APPLICATION FOR PERMIT TO DRILL OR REENTER

2. Name of Operator EOG RESOURCES INCORPORATED		8. Lease Name and Well No. DEEP ELEM 4 FED COM
3a. Address 1111 BAGBY SKY LOBBY 2, HOUSTON, TX 77002		9. API Well No. 30-015-54083
3b. Phone No. (include area code) (713) 651-7000		10. Field and Pool, or Exploratory PURPLE SAGE;WOLFCAMP (GAS)

PECOS DISTRICT DRILLING CONDITIONS OF APPROVAL

Proposed Wellbore
Design B

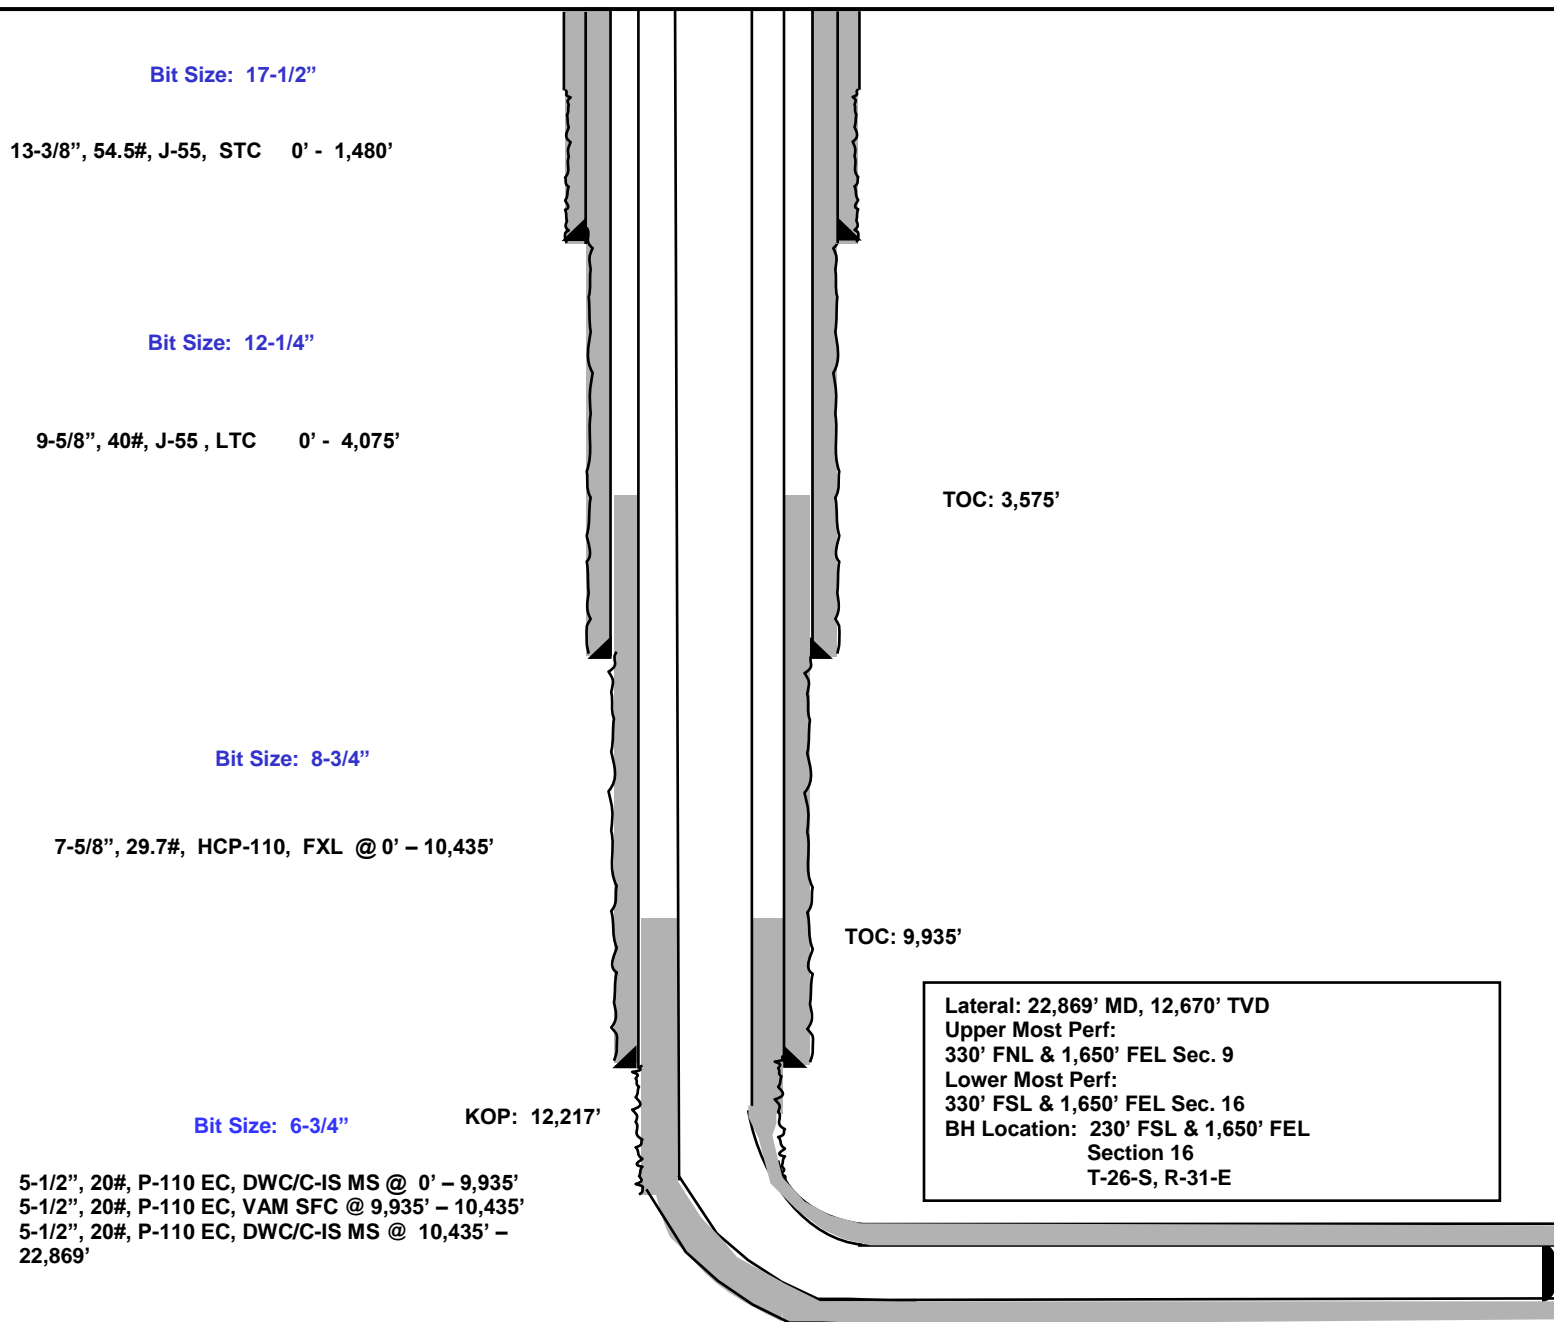
Operator is only approved for Design A. Design B is not to be utilized. If Design B is needed or any other change, please submit a NOI sundry to make the changes.
